**MAINE TURNPIKE AUTHORITY**

**ADDENDUM NO. 2**

**CONTRACT 2026.08**

**KENNEBUNK MAINTENANCE FIRE**

SHEET NUMBER: C-503

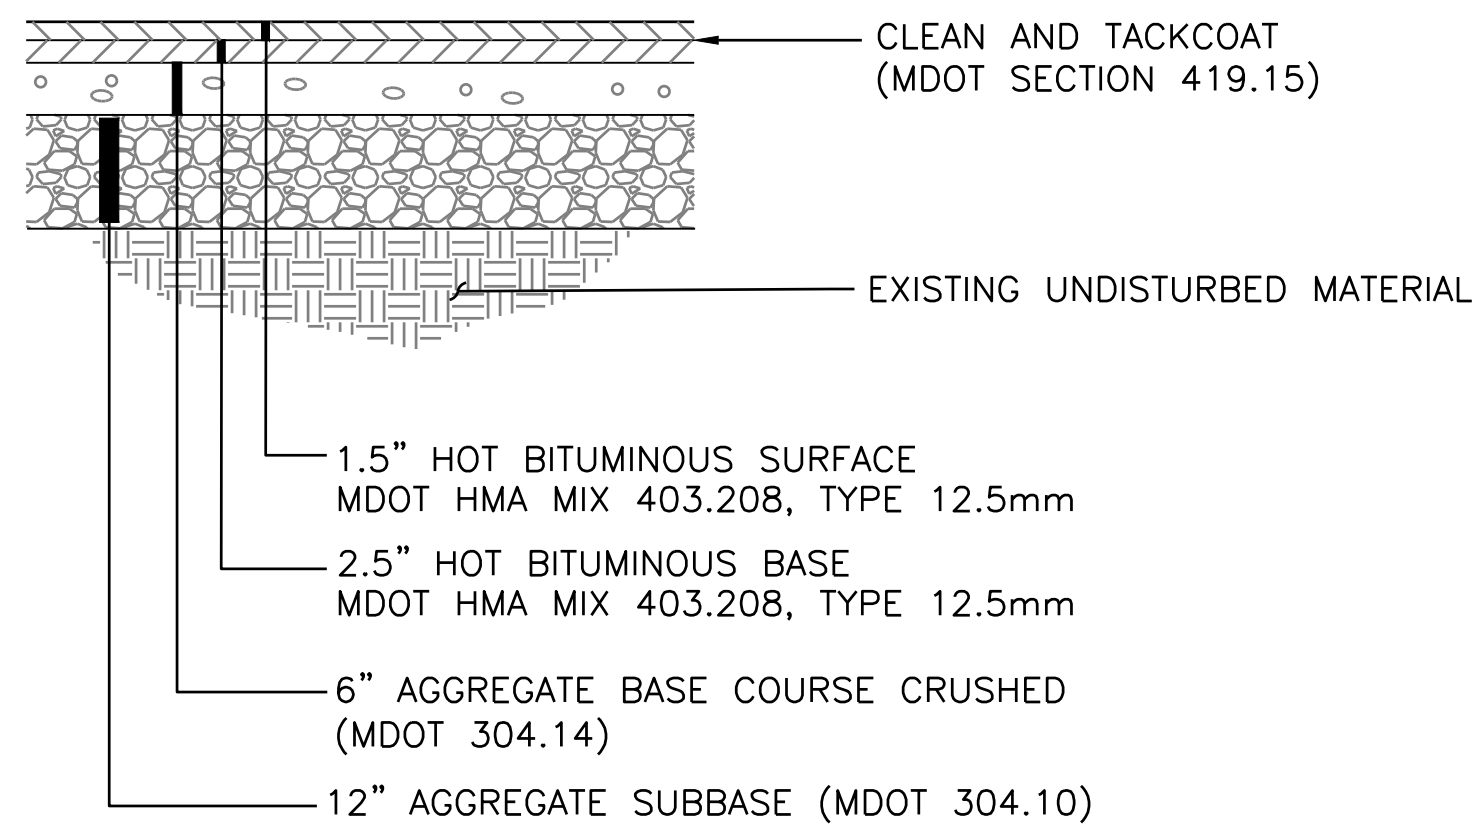
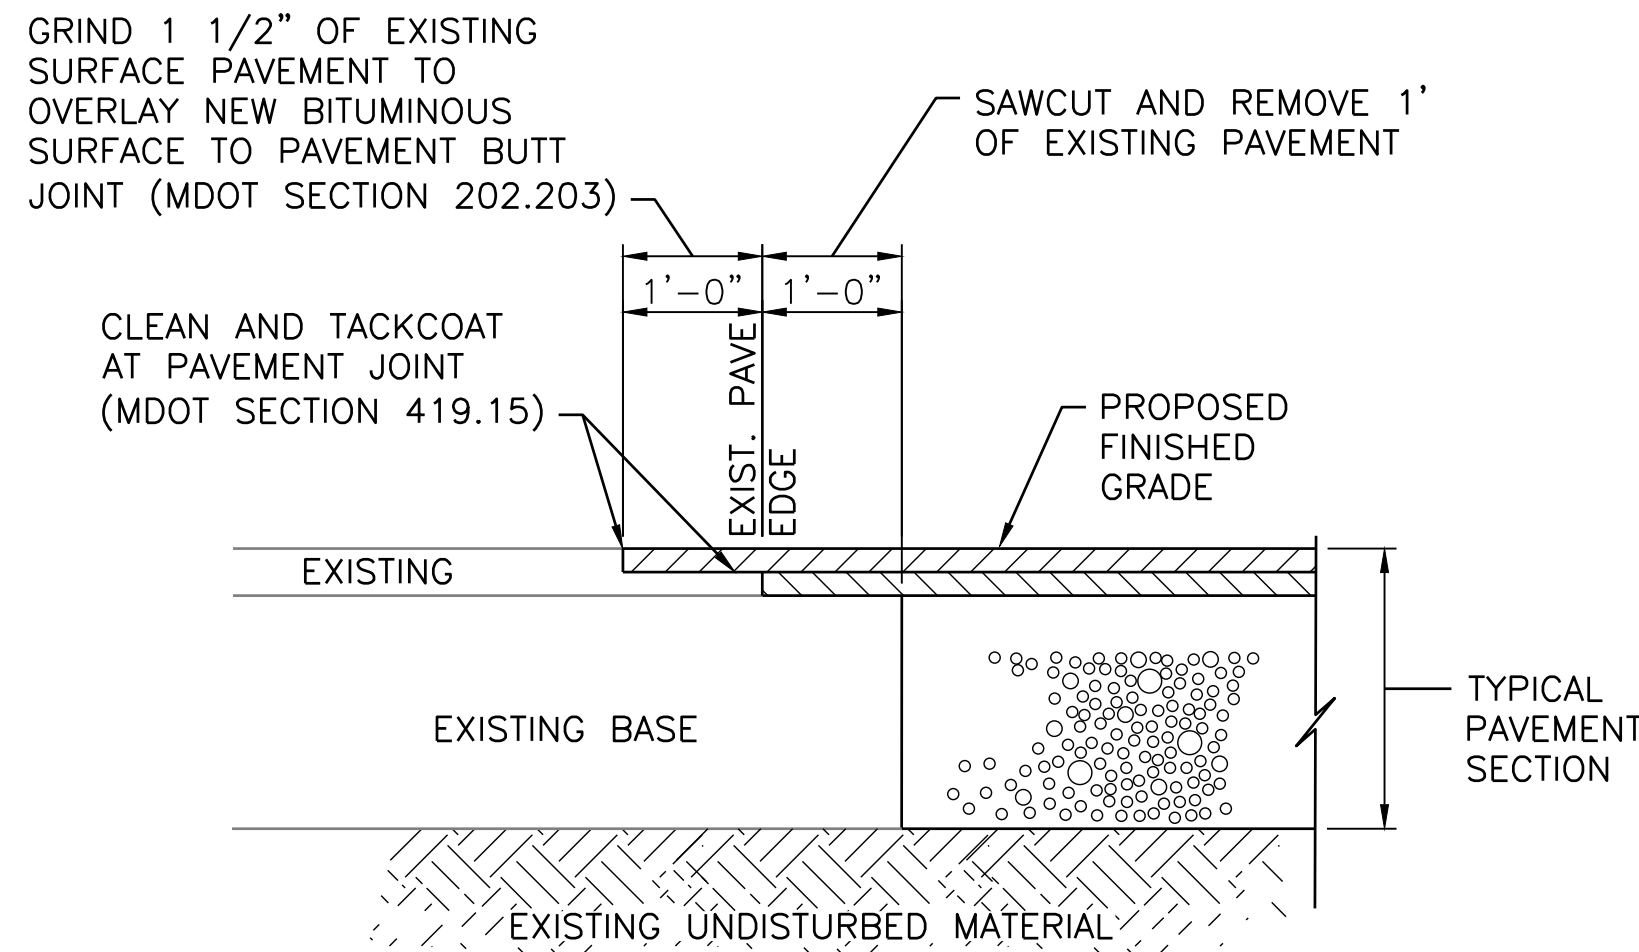
1. A combination of HDPE and Ductile Iron Piping has been identified on the plans. Note that AWWA C900 PVC is an acceptable alternative to HDPE.
2. All plastic pipe will require tracer wire. See Details 1 and 3 on C-503.
3. All ductile iron pipe must be poly wrapped.
4. Three 1” blow-off valves have been added to the plans. See C-103 and Detail 8 on C-504.
5. Four 6” gate valves have been added to the plans. See C-103.

CONDUIT PENETRATION THROUGH MASONRY WALL

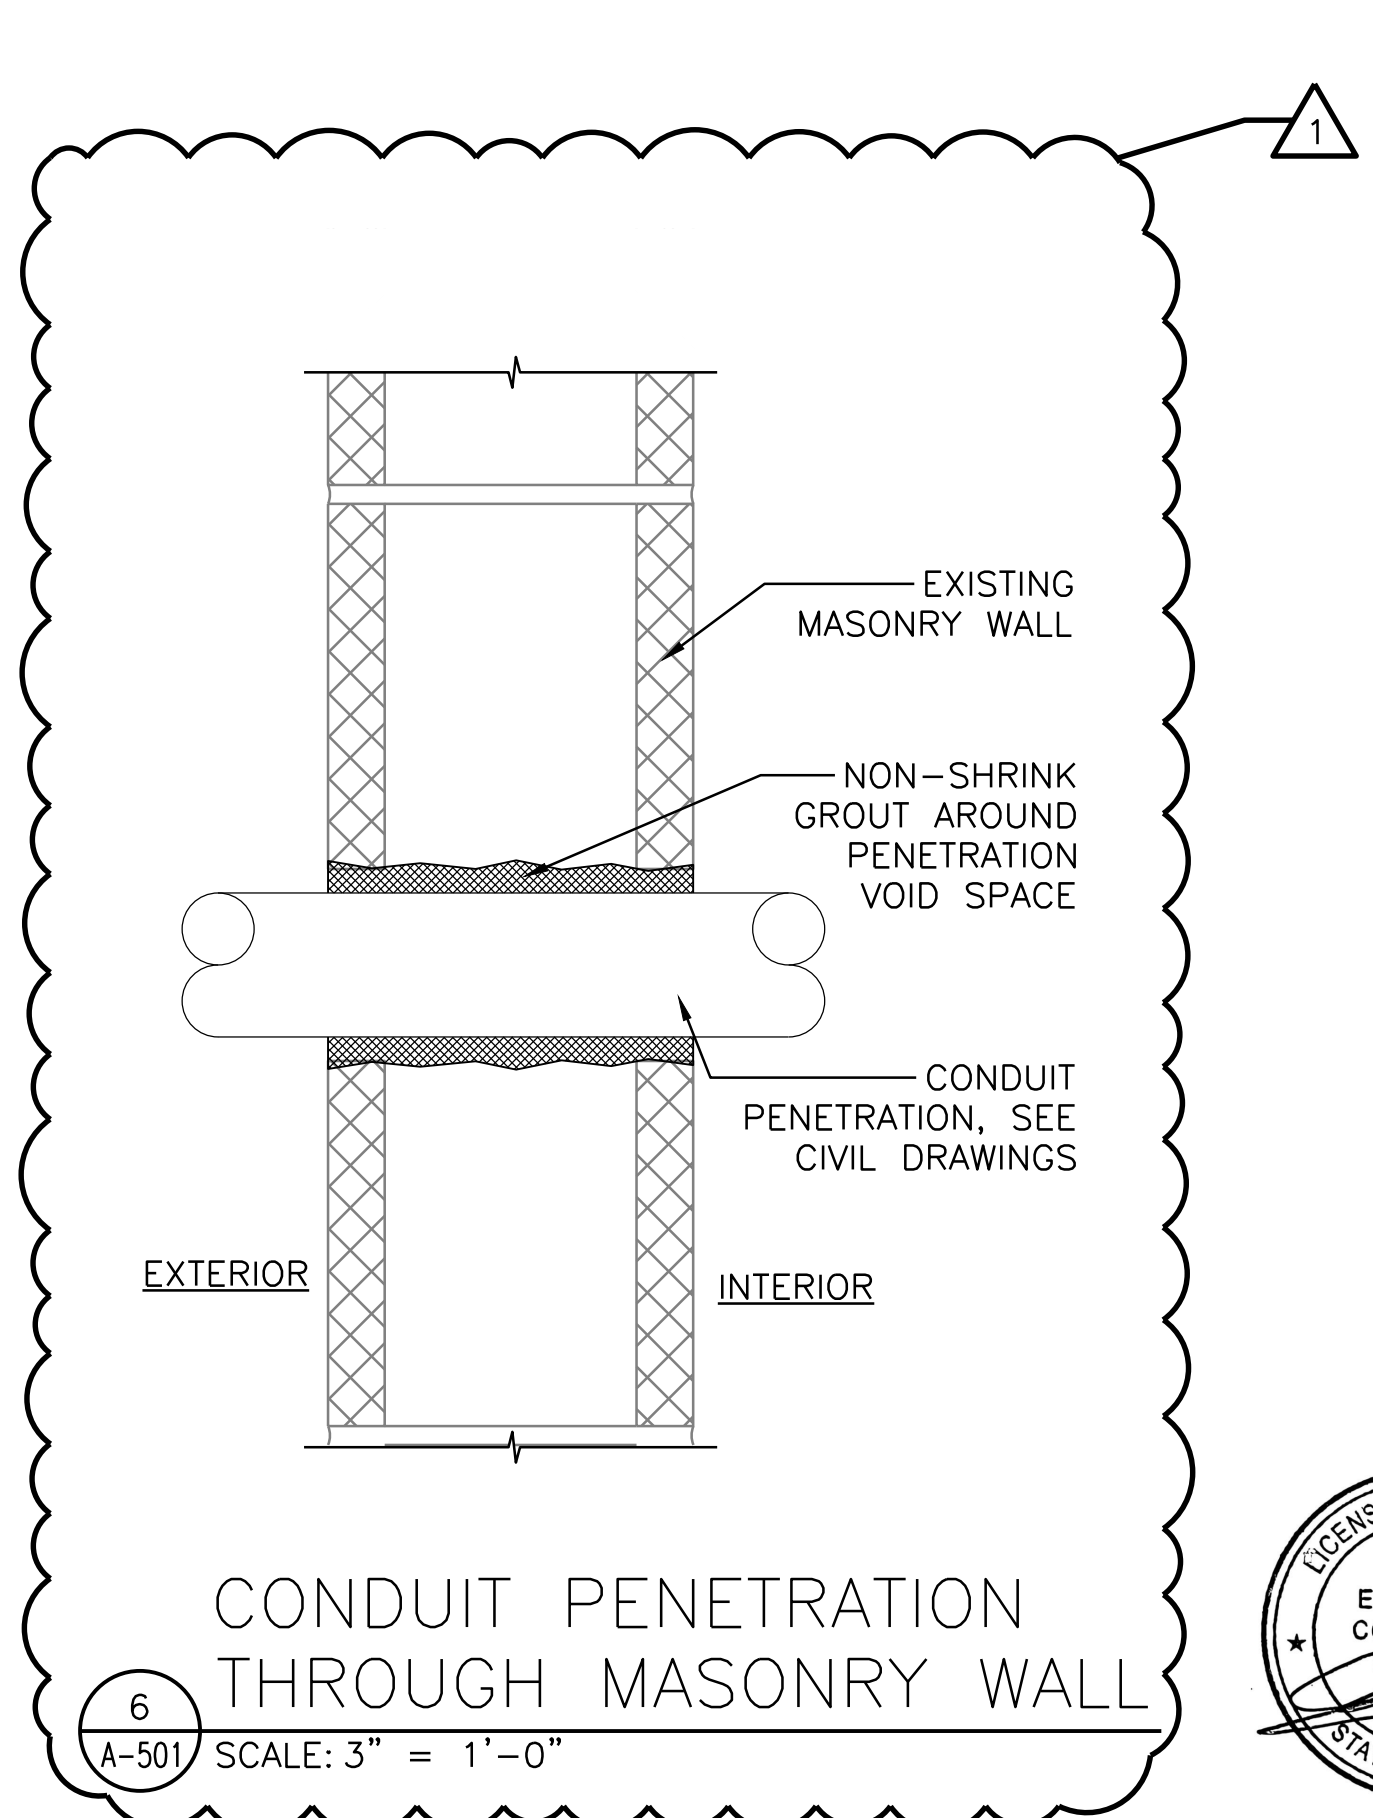
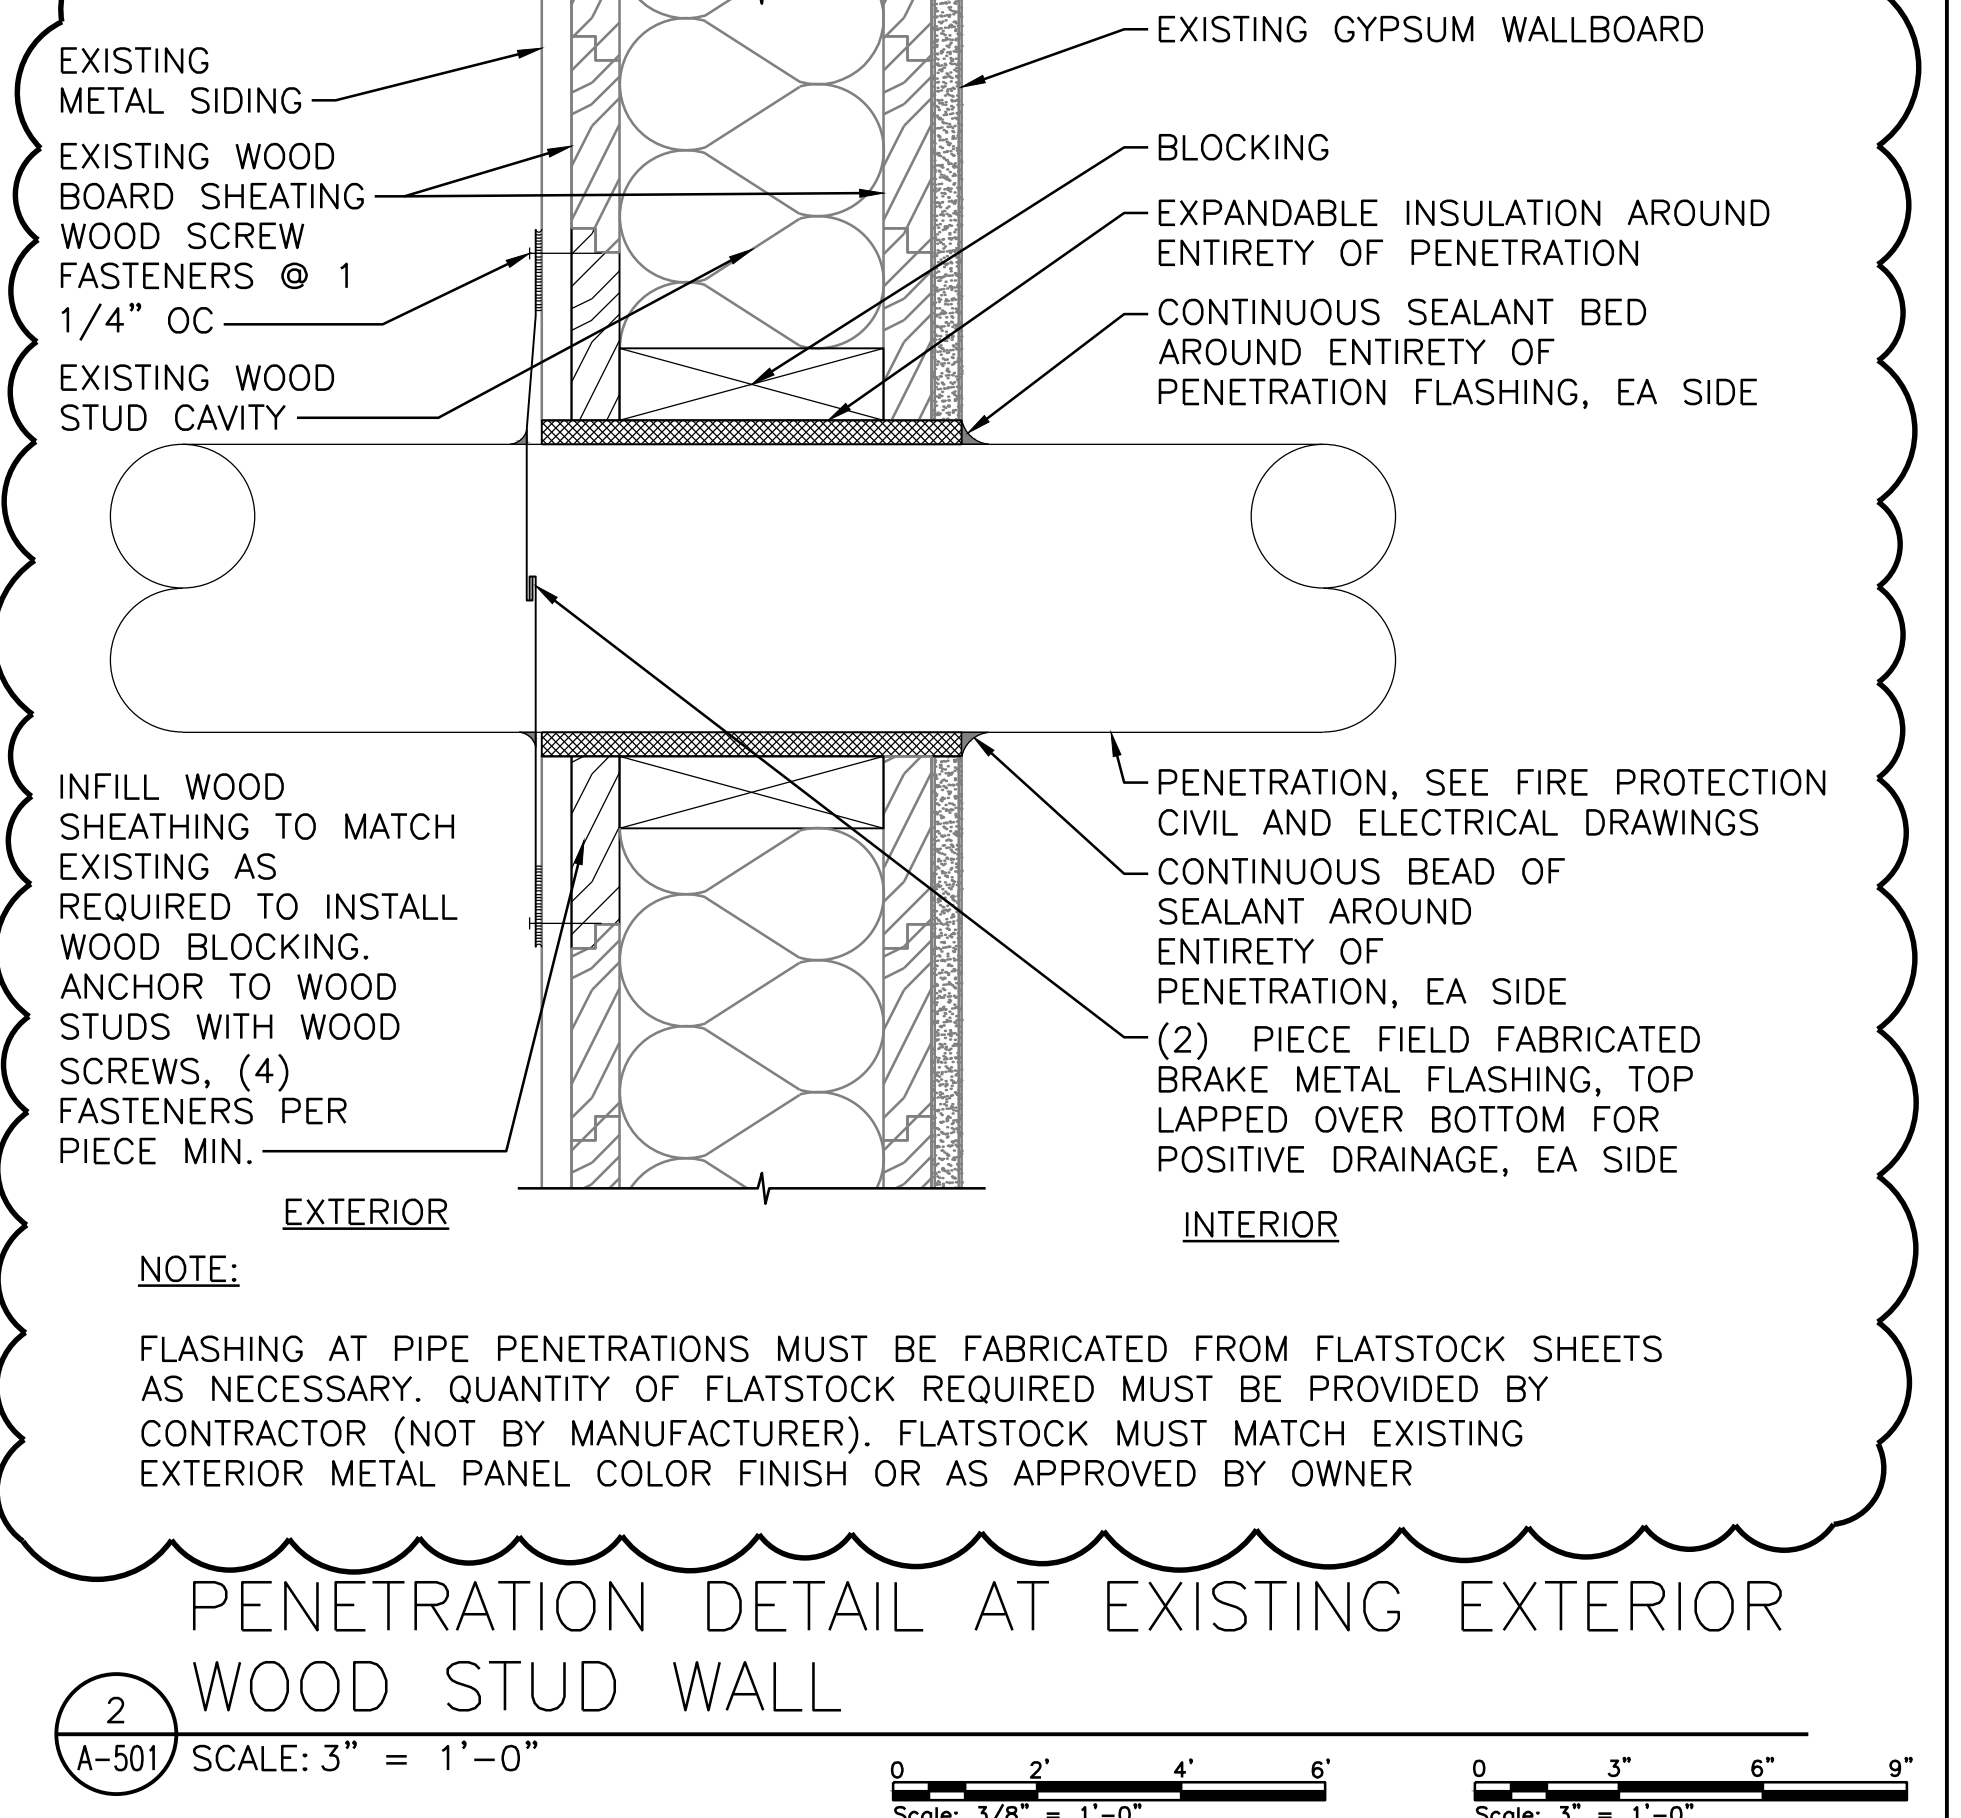
7. **Question:** Is there a detail showing the 3" schedule 80 conduits entering the building(s)?  
**Response:** Refer to details on revised Sheet 29 that is included in this Addendum Number 2. Contractor shall also account for PVC 90 degree elbow and expansion coupling fittings.
